**Record of Decision**  
**Precision Concepts Site**  
**Operable Unit 1**  
**On-Site Soil and Groundwater**  
**Town of Brookhaven, Suffolk County**  
**Site Number 1-52-158**

## **Precision Concepts Inactive Hazardous Waste Disposal Site Operable Unit 1 Town of Brookhaven, Suffolk County, New York Site No. 152158**

## **Responsiveness Summary**

**SUBJECT: COMMENTS ON THE PRECISION CONCEPTS SITE PROPOSED  
REMEDIAL ACTION PLAN FOR OPERABLE UNIT 1**

Figure 2  
Site Plan and Sampling Locations

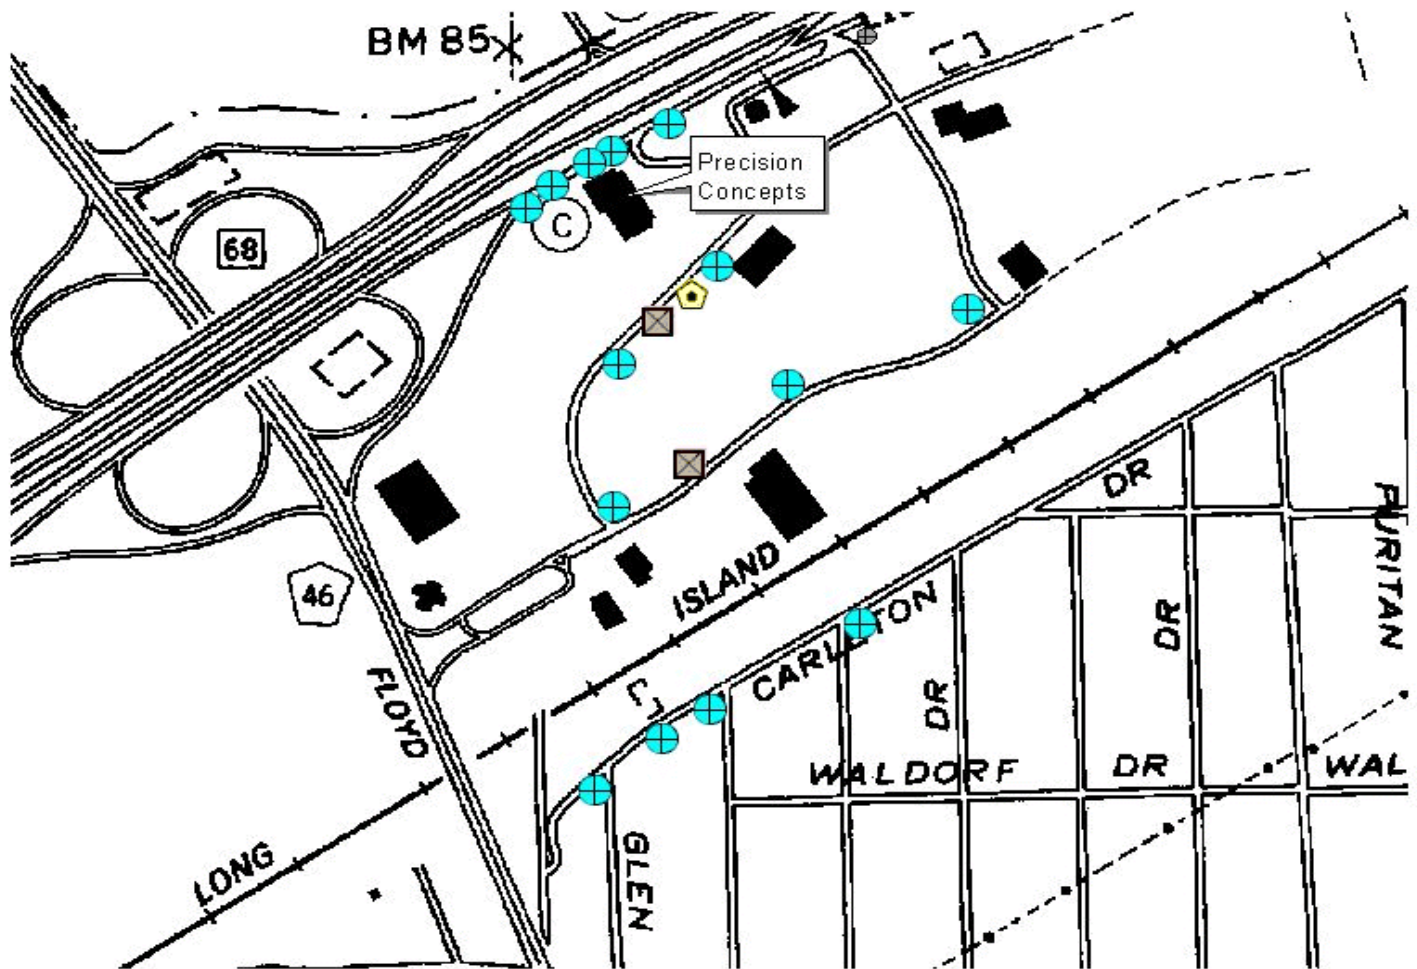
Of the 11 Geoprobos that were performed as part of the on-site (Operable Unit 1) investigation only three appear to be in a location that was identified during the previous investigation as being in a location generally consistent with the previously identified (1990) high concentration groundwater plume. The previous (1990) investigation showed a very narrow high concentration plume at very discreet depth intervals. The highest concentration found was 9,300 ppb of 1,1,1-trichloroethane (TCA) at 31-40 feet into the water table. No samples were taken at this same depth interval (only at 20 feet and 40 feet into the water table) during the recent field effort. The one sample that detected TCA at 4.9 ppb (GSP-7) was obtained at the water table. This location is generally consistent

with the previously identified plume, however, the high concentrations were identified at the 30-foot depth interval below the water table, and no samples were taken here.

1. Of the 11 Geoprobe samples that were performed as part of the on-site (Operable Unit 1) investigation only three appear to be in a location that was identified during the previous investigation as being in a location generally consistent with the previously identified (1990) high concentration groundwater plume. The previous (1990) investigation showed a very narrow high concentration plume at very discrete depth intervals. The highest concentration found was 9,300 ppb of 1,1,1-trichloroethane (TCA) at 31-40 feet into the water table. No samples were taken at this same depth interval (only at 20 feet and 40 feet into the water table) during the recent field effort. The one sample that detected TCA at 4.9 ppb (GSP-7) was obtained at the water table. This location is generally consistent with the previously identified plume, however, the high concentrations were identified at the 30-foot depth interval below the water table, and no samples were taken here.

The groundwater sampling points were sufficient to ascertain if groundwater contamination existed on-site. The Geoprobe groundwater sampling screen is 3.5 feet long and the sampling interval spanned from 36.5 to 40 feet below the water table. This spans a portion of the 31 - 40 feet of the previous sampling interval.

Plumes of contamination on Long Island tend to sink as fresh water recharges into the surface above them. If the 9,300 ppb of TCA detected at 31 - 40 feet below the water table originated at the site, the contaminant plume would have migrated from the source over a distance of about 500 feet to the sampling location. If there was an on-going source of that contamination, it would have been evident in the on-site samples. The off-site groundwater conditions documented in 1990 will be studied in the OU2 investigation.

## SCDHS 1990 Groundwater Sampling Locations

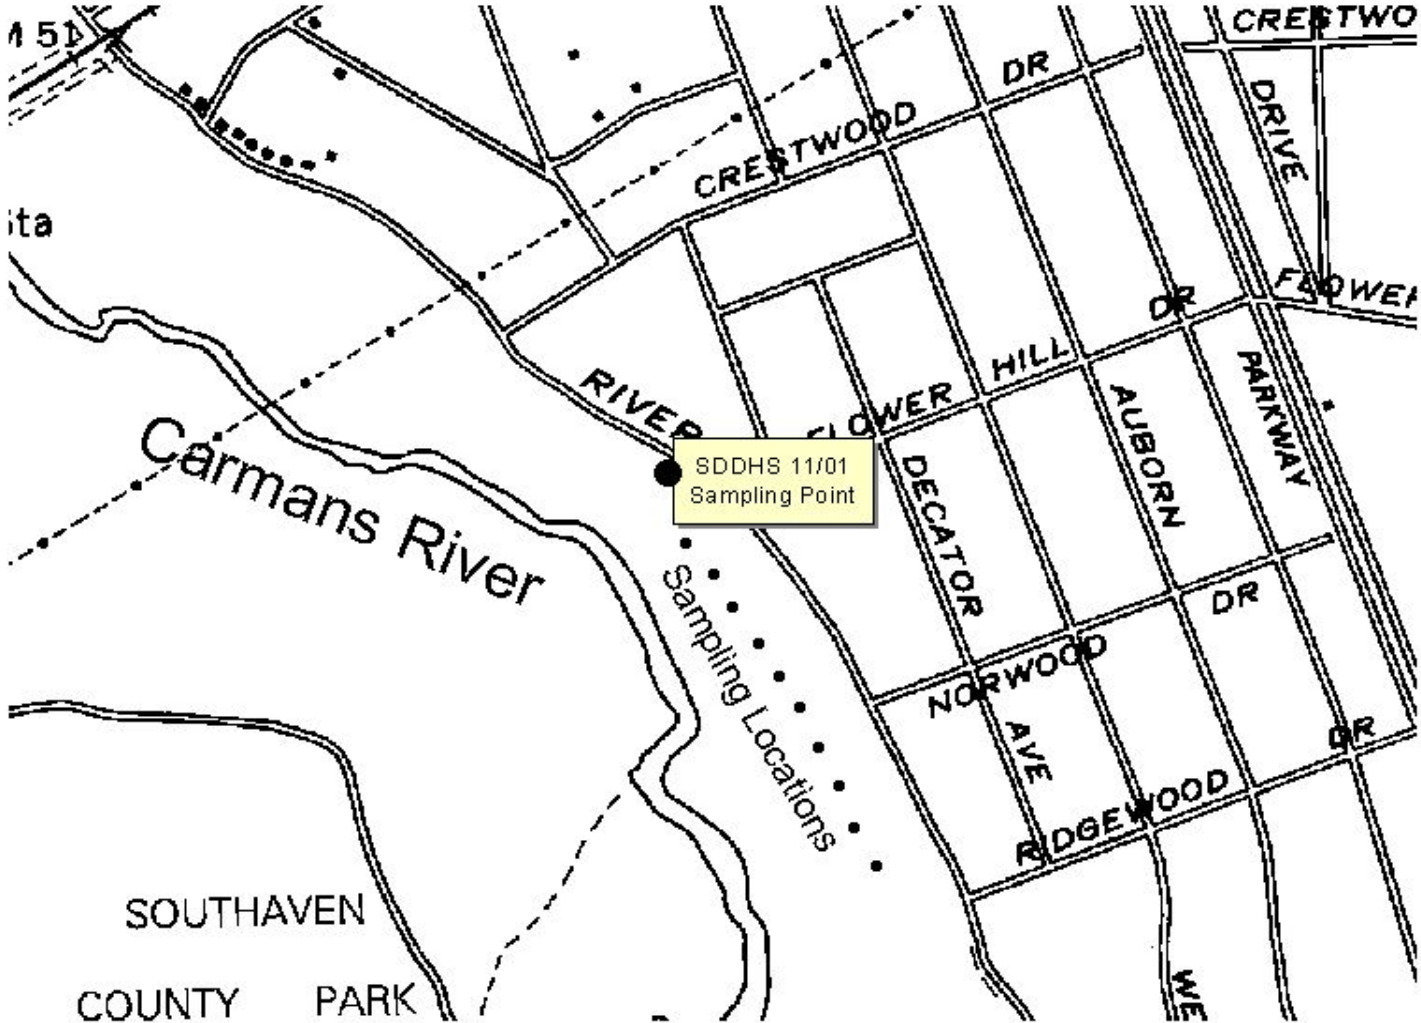
The previous plume delineation (1990) in the vicinity of Precision Concepts should be shown on the map showing the more recent investigation. A scale should be included on the maps so the distances between Geoprobe sampling locations can be determined.

4. The previous plume delineation (1990) in the vicinity of Precision Concepts should be shown on the map showing the more recent investigation. A scale should be included on the maps so the distances between Geoprobe sampling locations can be determined.

The suspected 1990 plume was never delineated in part because no on-site source was identified. The 1990 SCDHS groundwater sampling points and the points where contamination was detected are represented in Figure 3. The 2000 NYSDEC on-site groundwater sampling locations, represented on Figure 2, were placed fifty feet apart in a line perpendicular to groundwater flow. Due to differences in scale, the 2000 sampling locations and the 1990 sampling locations will not fit on the same figure.

A scale has been added to Figure 3. However, the Geoprobe sampling designations on the figure are approximate.
